**Report: TAB REPORT**  
**Function: Test, Adjust, & Balance**  
**Date: 07/24/2023**

## 06-24-24 WALGREENS #1769 - DENVER, CO

Project: 06-24-24 WALGREENS #1769 - DENVER, CO

**Dirty\_Filters**  
**06/19/2024**

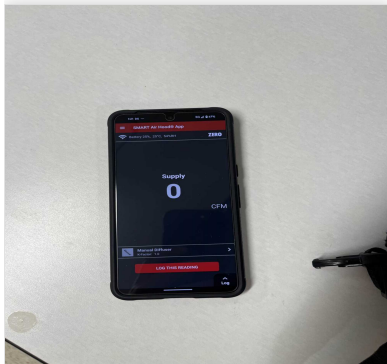
**Issue Name :** RTU Final Filters  
**Description :** Recommended to install the appropriate sized MERV 8 or better throwaway filters in the RTUs for improved filtration.  
**Created By :** National TAB                      **Assigned To :** National TAB - Stephen Tassinaro  
**Status :** Open  
**Priority :** Medium                                      **Asset Tag :**  
**Originated Date :** 07/20/2023 - Stephen Tassinaro - National TAB

- **06/17/2024 National TAB - Stephen Tassinaro**
  - MERV 8 filters now installed in all units, but they are dirty and due for replacement.
